SERVICE BULLETIN

ENGINE NACELLE — EARTH POSITION RELOCATION (MOD N890)

NMD-54-5
Page 2 of 7

Figure 1 Details of Fire Detector Mountings

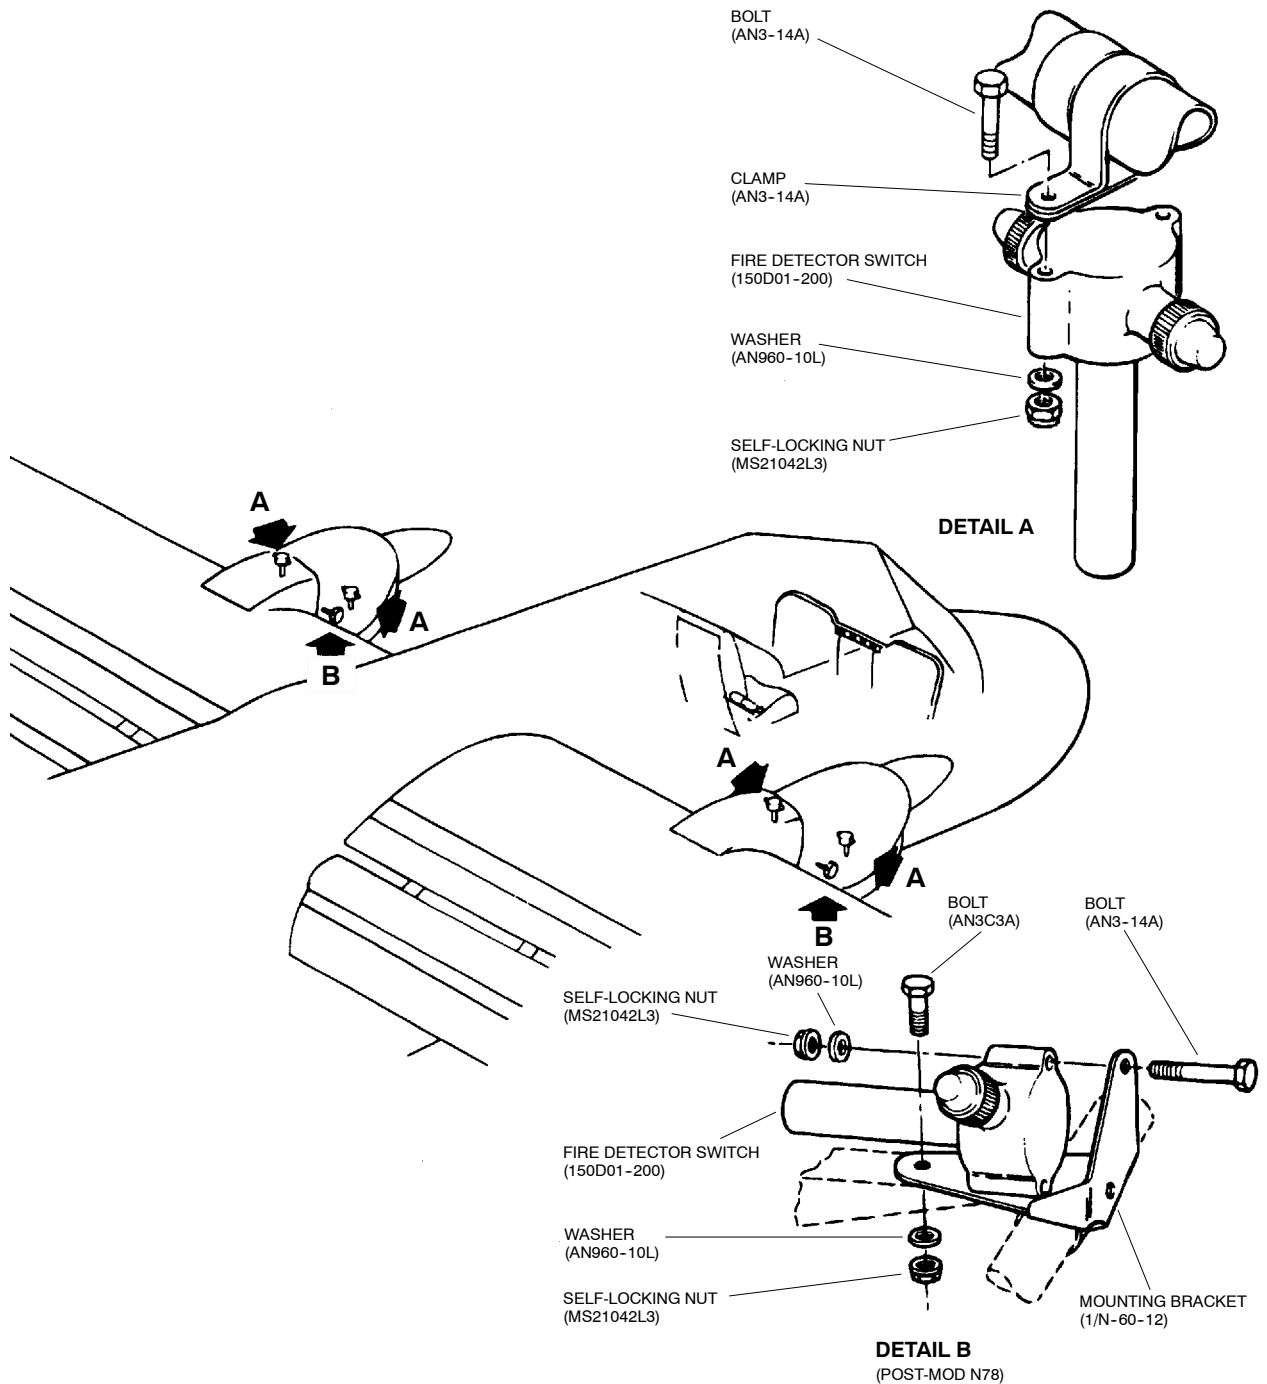
- (4) Remove Lower Front Fairing (Ref MM Chap 71-10-00, Para 1.G.).
- (5) Locate (Ref Fig 1) and remove Fire Detector Switches from the mounted positions (Ref MM Chap 26-10-00, Para 1.E.). Remove and discard earth wire from each switch.

It is only necessary to remove earth wires W3A18N, W4A18N and, if Mod N78 fitted, W81A18N.

- (6) Make up new earth wires with wire MS25038/1-18-9 and lugs MS25036-102 as follows:
 - (a) LH Fire Detector Switch, Ref W151A18N, 90 inches,
 - (b) RH Fire Detector Switch, Ref W152A18N, 30 inches, and

- (c) Centre Detector Switch (if fitted by Mod N78), Ref W153A18N, 44 inches.
- (7) Attach earth wires to relevant terminals in the Fire Detector Switches. Refit Fire Detector Switches as per MM Chap 26-10-00, Para 1.F.

Figure 2 Details of new earth point

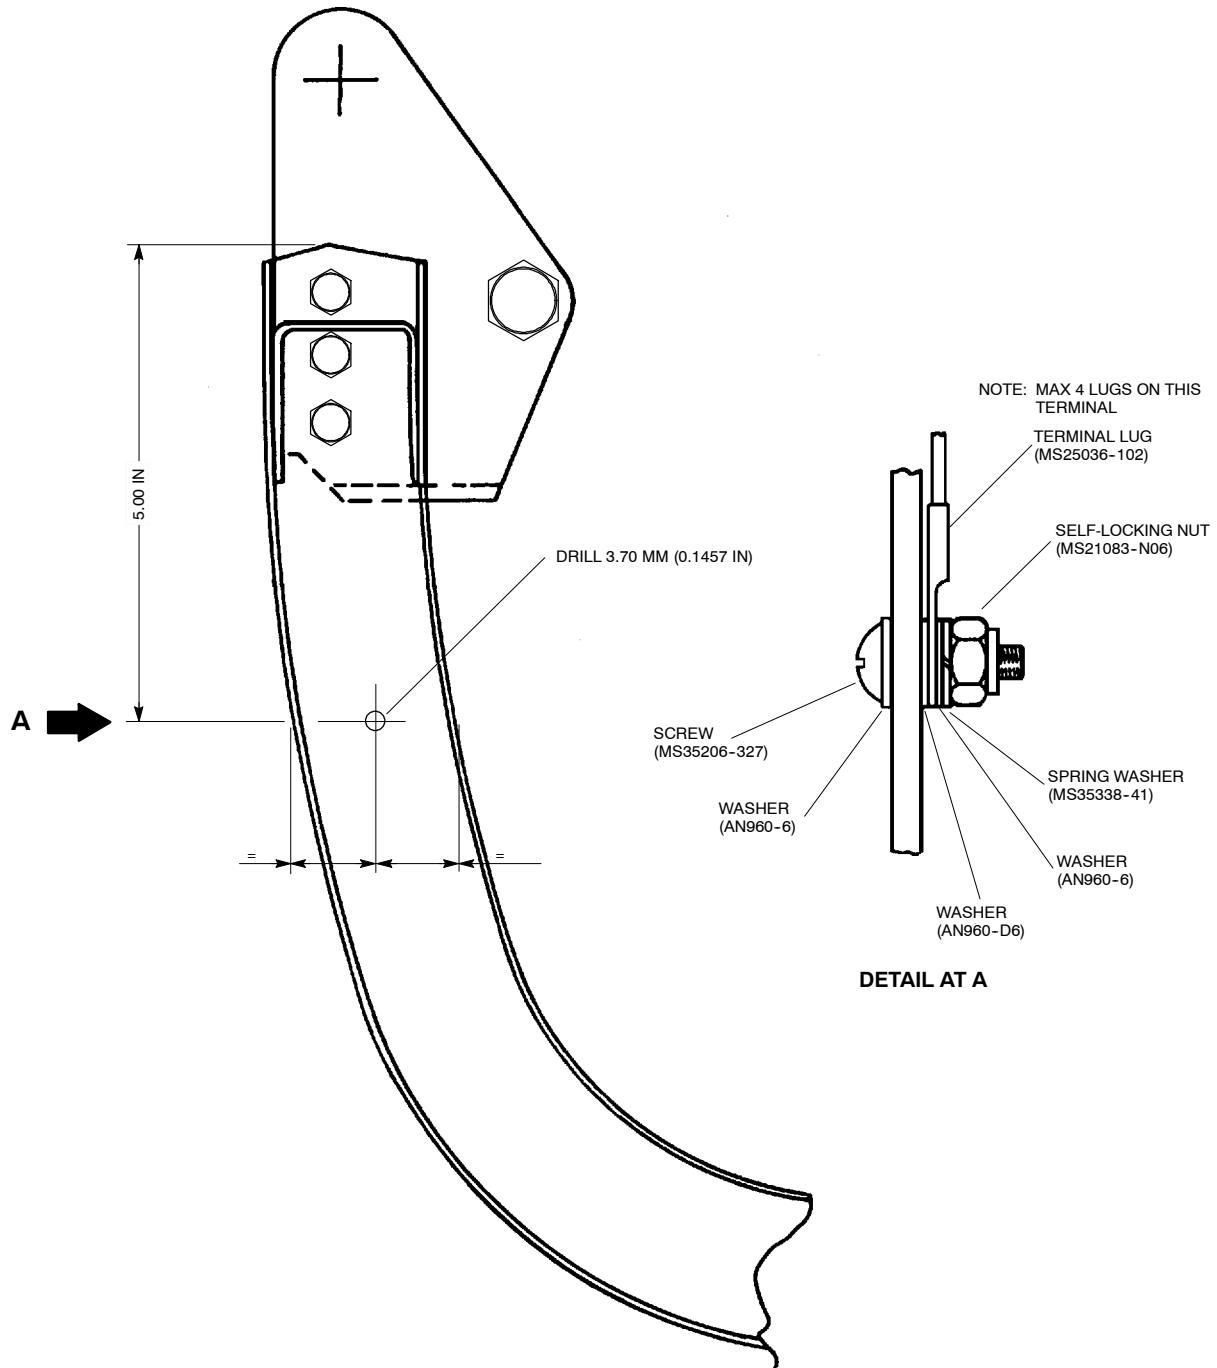
- (8) Drill a 3.70 mm (0.1457 in) hole at the new earth point on the RH side of the lower mounting yoke (Ref Fig 2). Prepare the surface as per MM Chap 20-20-00.

- (9) Run earth wires to the new earth point. Where possible tie earth wires to existing looms. Attach with screw (MS35206-327), plain steel washer (AN960-6), aluminium washer (AN960-D6) placed as per Figure 2, spring washer (MS35338-41) and self-locking nut (MS21083-N06). Refinish the surface as per MM Chap 20-20-00.

Figure 3 Mounting of Torque Oil Pressure Switch

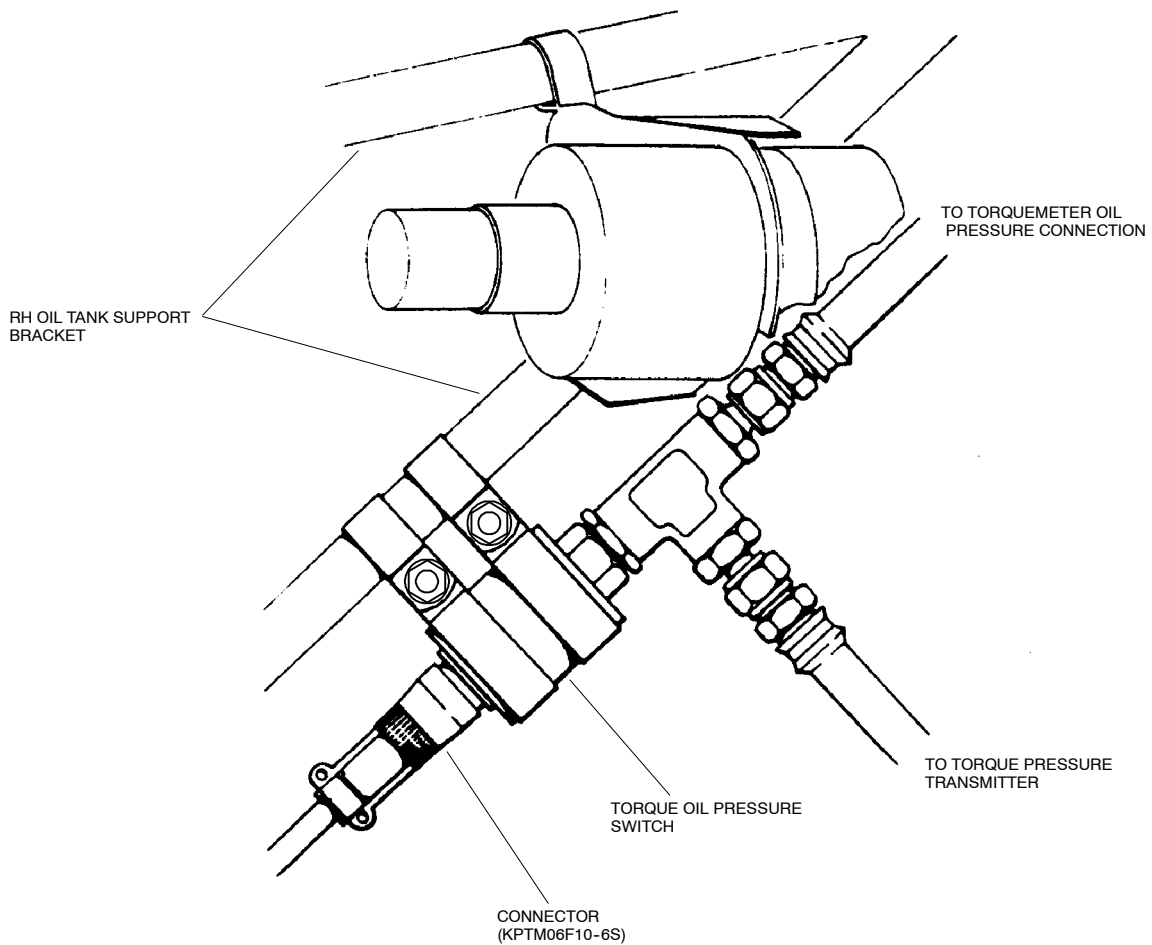
- (2) Locate Torque Oil Pressure Switch (Ref Fig 3), and remove electrical connector.

- (3) Open connector, locate Pin F and disconnect wire K24A18N (or K38A18N) and disconnect from present earth point.
- (4) Make new earth wire using wire MS25038/1-18-9 and lug MS25036-102 of length 50 in. Label as K24A18N.
- (5) Connect to Pin F in connector, reassemble connector and refit to Torque Oil Pressure Switch.
- (6) Run earth wire to the new earth point (Ref Fig 2). Where possible tie earth wire to existing looms. Connect as per Para 2.A.(9).
- (7) Refit Upper and Lower Front Fairings (Ref MM Chap 71-10-00).
- (8) Close and secure Upper and Lower Cowls (Ref MM Chap 71-10-00).
- (9) Carry out Autofeather function test as per Maintenance Practices of CO G214.
